Bent Grass East Commercial Filing No. 3

Updated Traffic Impact Analysis

AUGUST 20, 2021

LSC Responses to TIS Redlines

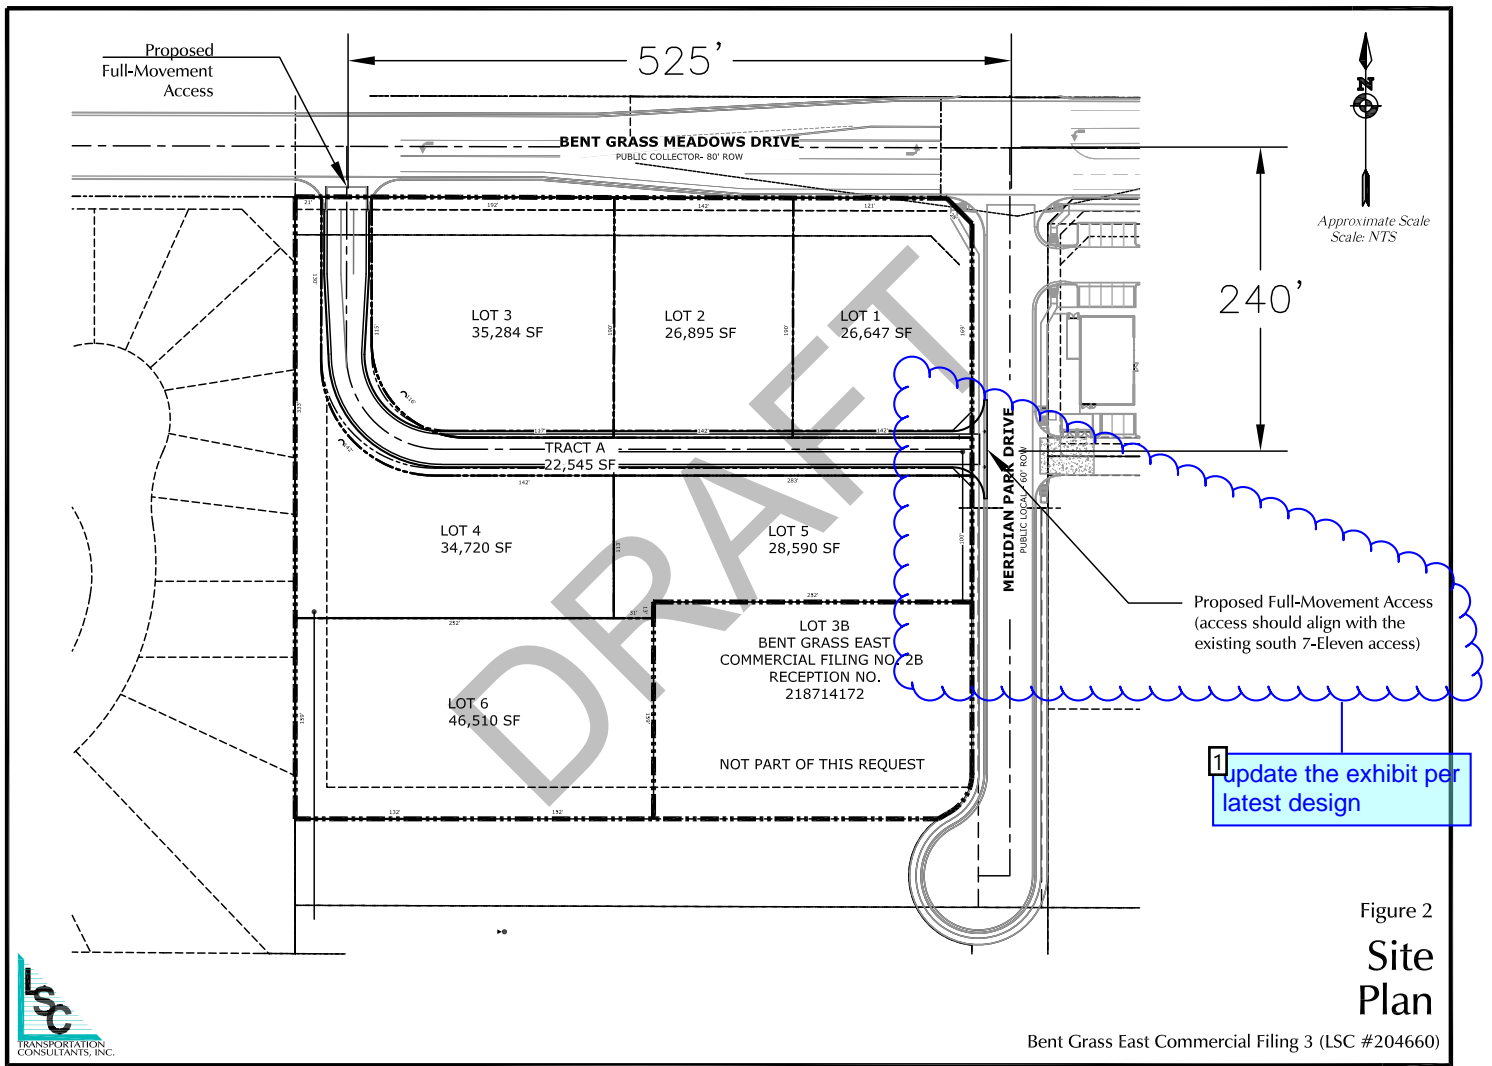
Please include in the list of improvements the southbound right turn lane on Meridian Park Drive at the site access.

Update per comments provided.

LSC Response: Added as requested.

LSC Response: Modified in the updated table.

Figure 12

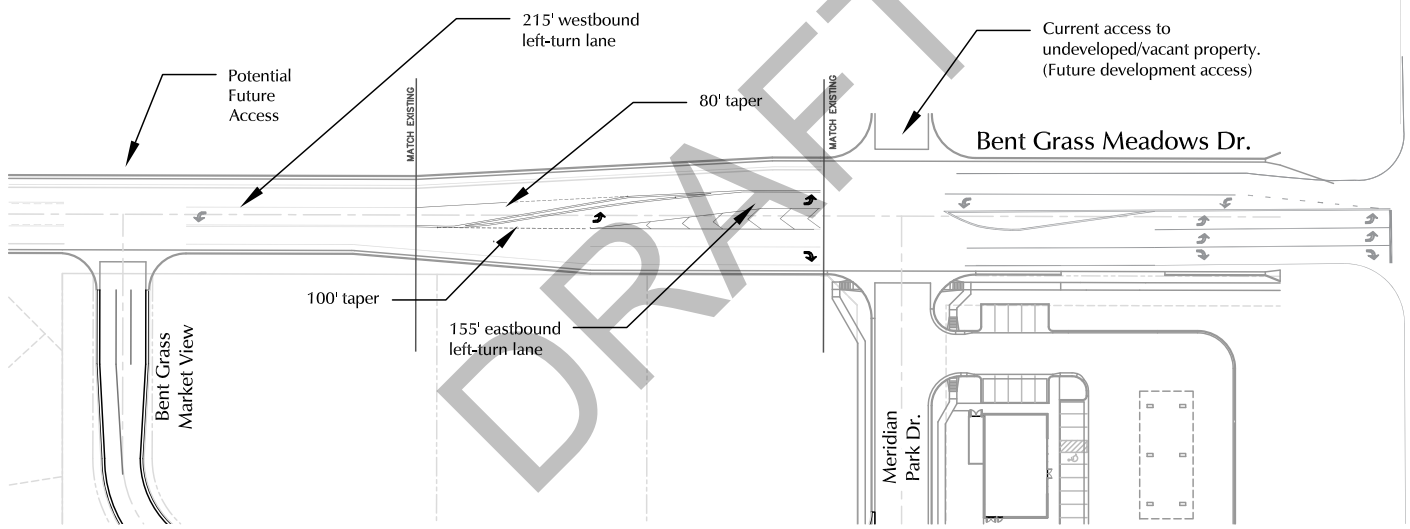
[update the exhibit per latest design](#)

1 Please update the exhibit accordingly per comments provided

Please update the exhibit accordingly per comments provided

LSC Response: This figure has been updated.

LSC Response: This figure has been revised to reflect the TWLTL and to address the comments.
